# HNDFUE Impact Assessments – Muir Mhòr Outcome Summary

May 2025

*Map showing the design change – locations are illustrative and not to scale. Final design configuration is subject to further detailed network design.*

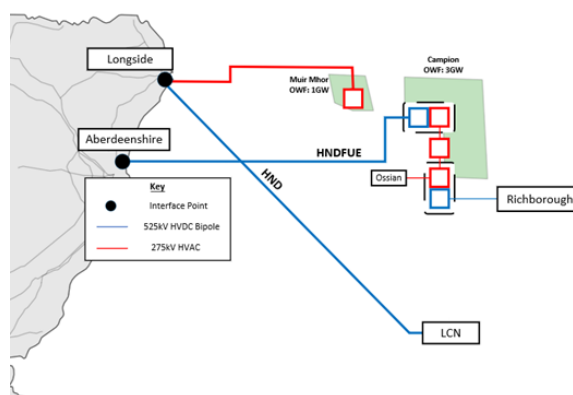
The proposed change was focussed around a localised area of the HND FUE Cluster – the northern half. The changes proposed consisted of multiple network topologies being submitted by Muir Mhòr (coordinated and radial options) primarily aiming to facilitate a modular build out delivery model. This approach would allow the transmission component connecting Muir Mhòr Offshore wind farm to the onshore system to be delivered with advancement of the existing plan. Supporting technical reports were shared by Muir Mhòr to support the impact assessment process.

The proposed design change from SSEN-T considered a switch of landing locations for the two, 2 GW HVDC bipole subsea cables from the HND (initially Hurlie, proposed to move to Netherton Hub) reinforcement and HND FUE topologies (initially Netherton Hub, proposed to move to a new planned substation in the Aberdeenshire area). Supporting technical information was shared by SSEN-T to support the assessment of the proposed design change.

The conclusion of our analysis resulted in Muir Mhòr connecting directly to a substation at Longside in the Peterhead area emerging as the preferred option. With the original 2 GW HVAC reinforcement link that connected Muir Mhòr and Campion, being replaced with a 2 GW HVDC bypass link to Campion. The more coordinated bypass options provide opportunities for a modular build out approach. However, considering the contrasting delivery timelines of neighbouring projects, becoming independent of the 2 GW reinforcement link, was the only option for Muir
